## SINGAPOREAN NOTICES TO MARINERS

The monthly Notices to Mariners contain information required to keep charts and publications published by the Hydrographic Division, Maritime and Port Authority of Singapore up-to-date.

CORRECTION NO.	SNM EDN NO.	LAST CORR N NO.	CHART NO.	Location on Chart		
29 (2)	04	26	501	X

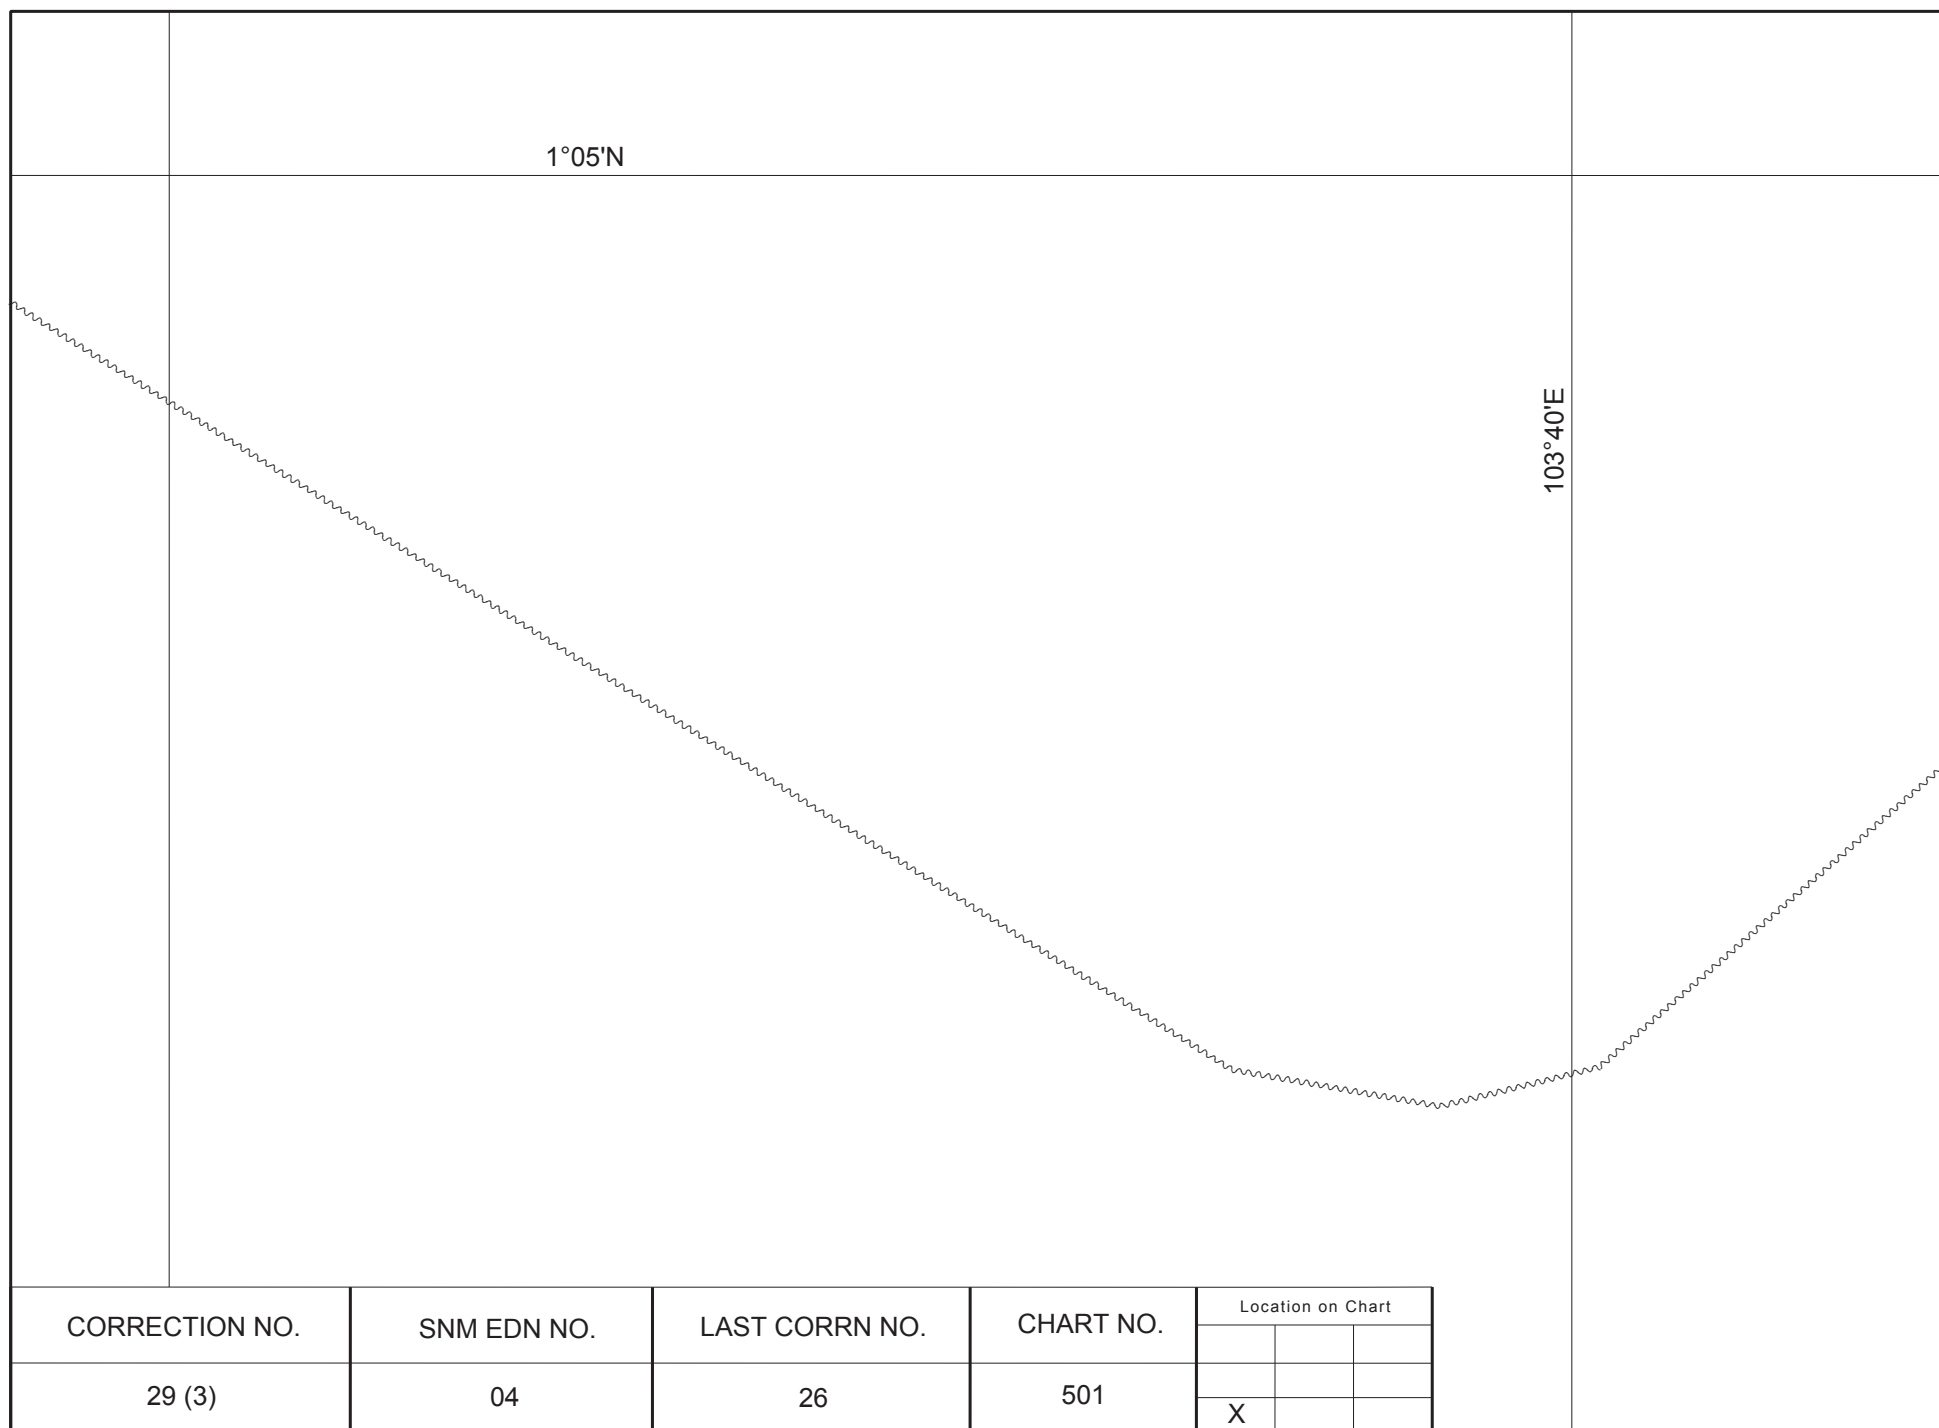
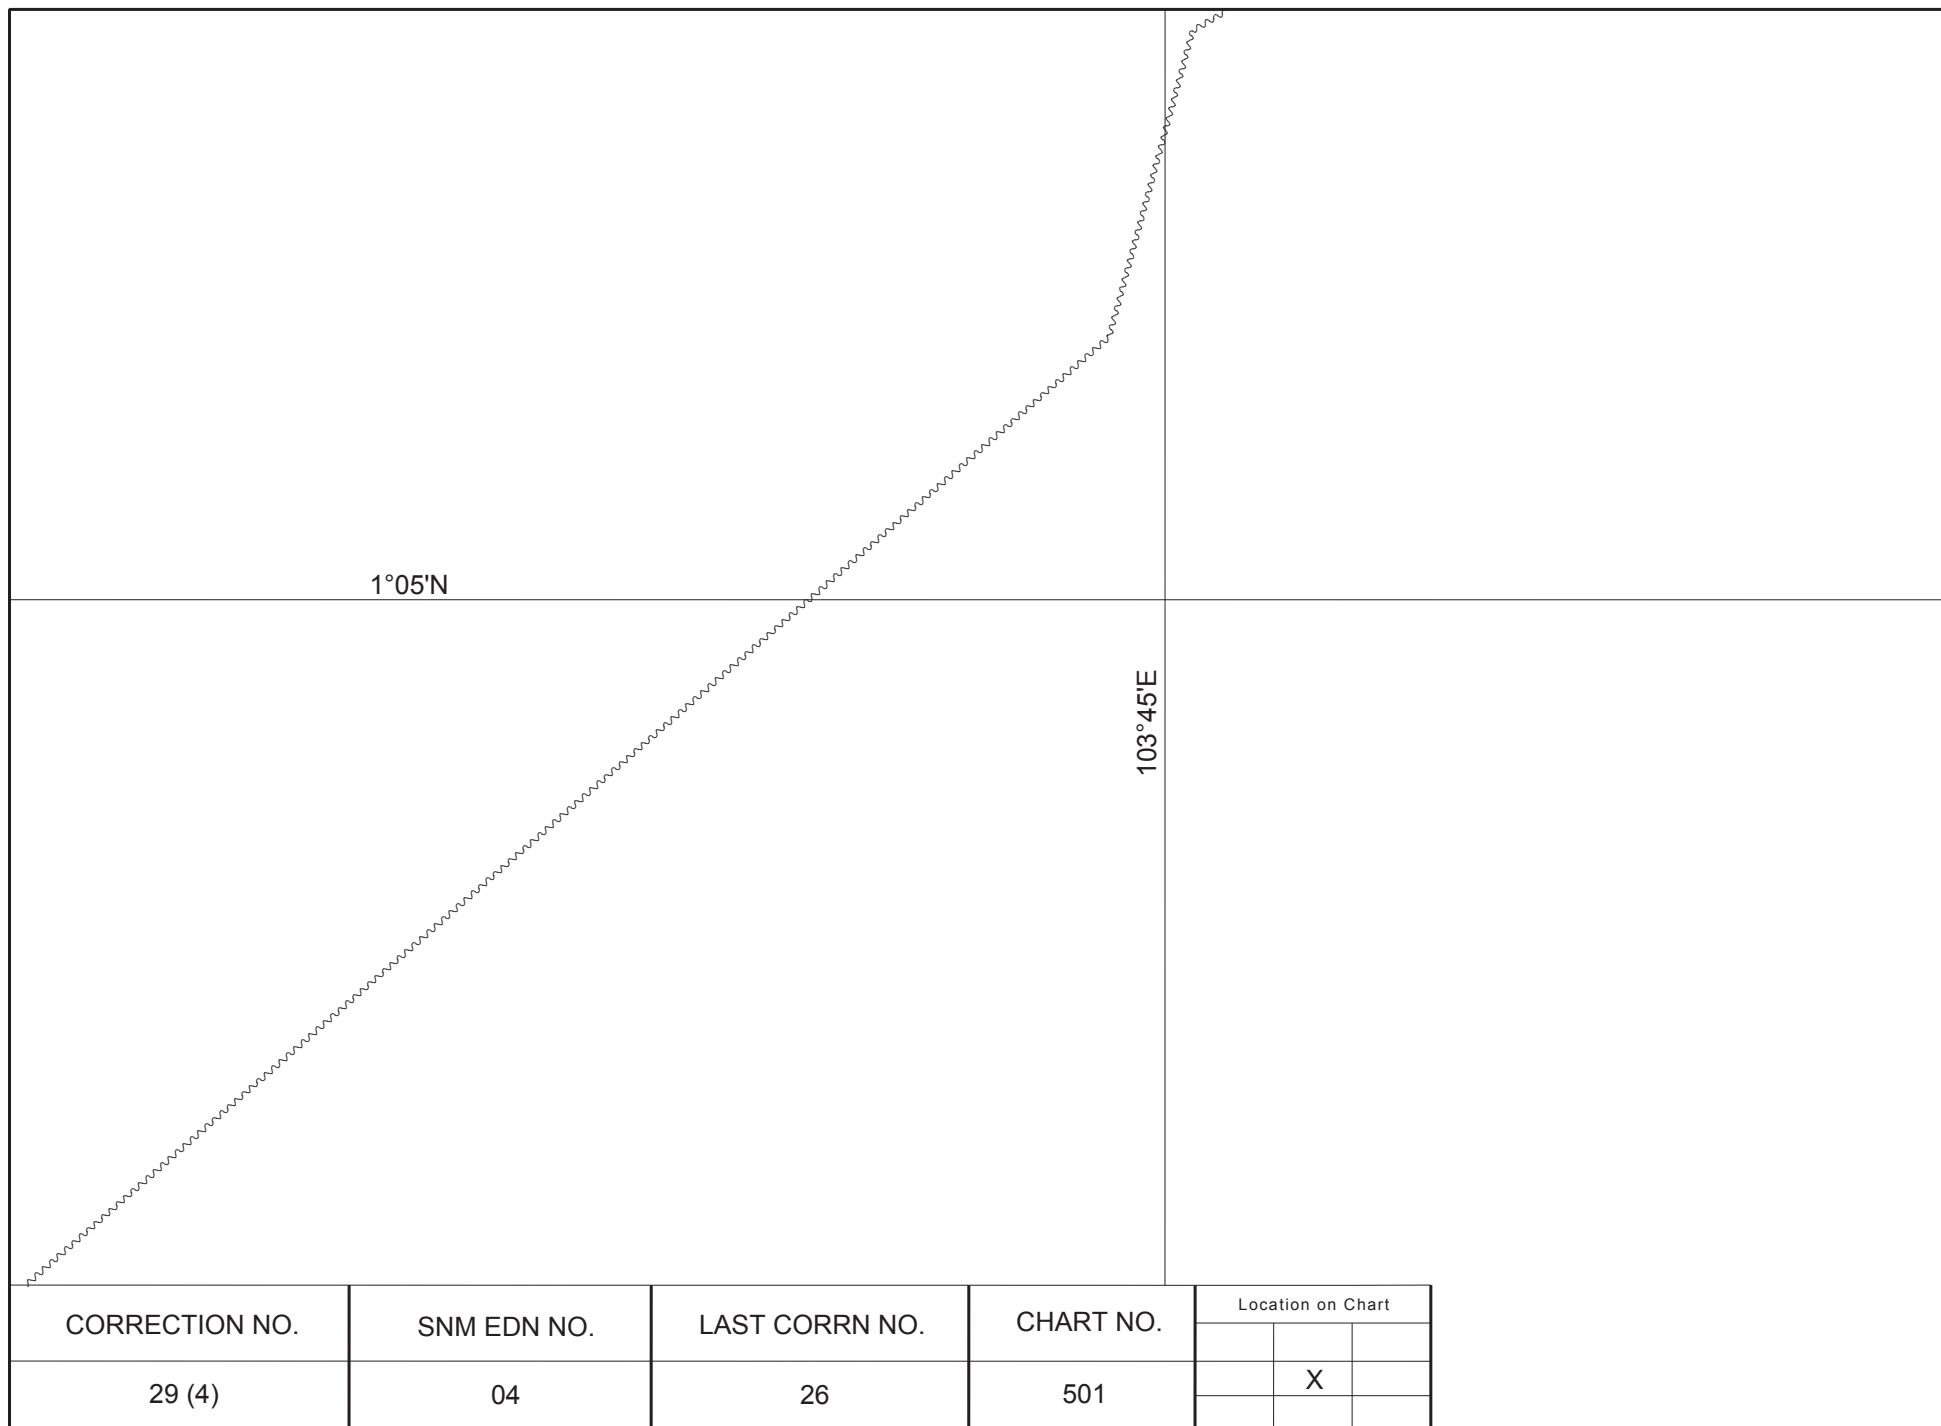
<b>501</b>	7 Ed 01/09/15 Last NM 26/2025	(Maritime and Port Authority of Singapore)	<b>*NM 29/2025</b>
<b>Insert</b>	submarine cable,  , joining:		1°12·98'N 103°37·19'E
			1°12·27'N 103°36·89'E
			1°11·66'N 103°35·93'E
			1°11·53'N 103°34·68'E
			1°06·81'N 103°31·50'E
			1°06·58'N 103°31·53'E
			1°04·53'N 103°34·46'E
			1°01·79'N 103°38·79'E
			1°01·66'N 103°39·53'E
			1°01·80'N 103°40·10'E
			1°05·94'N 103°44·80'E
			1°07·04'N 103°45·10'E
			1°11·73'N 103°53·08'E
			1°12·52'N 103°55·05'E
			(chart border)
